Presentation to OET

*How Motorola Proposal Fails to
Protect TV Viewers*

March 12, 2008

ET Docket No. 04-186

Figure 5-6. D/U Statistics at D = -28 dBm on Channel 30

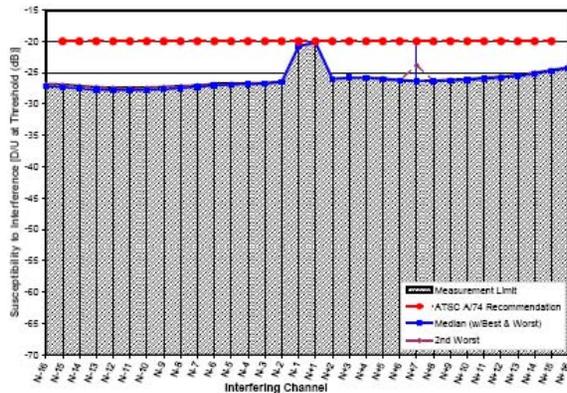
- Whitepaper suggests signal reductions can be much greater than -10 to -15 dB
- To meet D/U adjacent channel use would generally occur under strong signal conditions
 - -26dB/-28dB adjacent channel D/U protection ratios not conservative
 - FCC measured -20 dB not -40 dB
 - ATSC value is -20 dB not -33 dB for higher signal levels
